**Appendix A – Assessment of Effects on the Environment – Britomart  
Transport Centre Notice of Requirement for Alteration to Designation  
2501, including supporting Appendices (A – E), dated 25 June 2021**

## NOTICE OF REQUIREMENT FOR A DESIGNATION UNDER SECTION 181(1) OF THE RESOURCE MANAGEMENT ACT 1991

**CITY RAIL LINK LIMITED (CRL) as Requiring Authority under section 167 of the Resource Management Act 1991 (RMA) gives notice of a requirement to Auckland Council to alter City Rail Link Designation 2501 in the Auckland Unitary Plan (Operative in Part)**

Figure 8: Site access

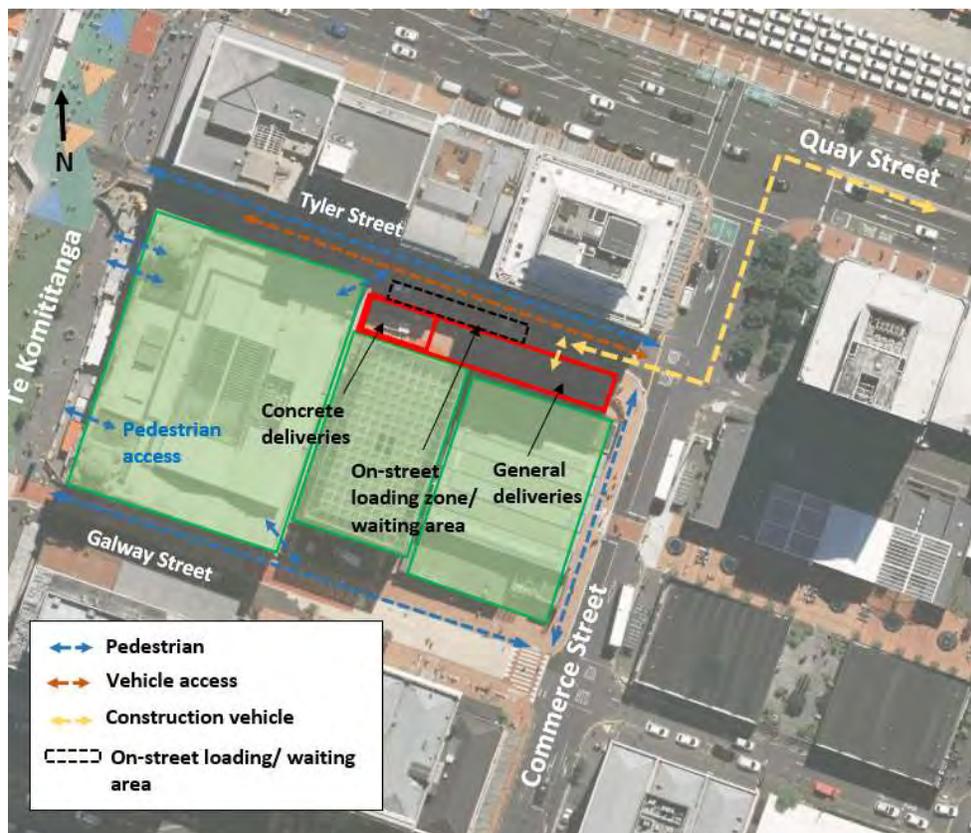
*Explanation: Figure 8 of the ITA indicates all movement from Quay Street will be to and from the east. The text does not provide any further description of movement patterns beyond the site, so on our reading we would assume all construction traffic will follow a traffic management plan that supports the movements shown in Figure 8. Confirmation of the movement will ensure that effects associated with heavy vehicle access is appropriately considered.*

Figure 8 within Section 3.1 of the ITA and Figure 2 within Section 3.2 of the CTMP both showed “Site Access”. The text within Section 3.3 of the CTMP stated that the routing of construction vehicles is shown in Figure 2 above, namely approaching the site from Quay Street east, and turning left into Commerce Street, with vehicles exiting the site also leaving via Quay Street east. In other words, we can confirm that no truck movements are proposed via Quay Street, west of Commerce Street.
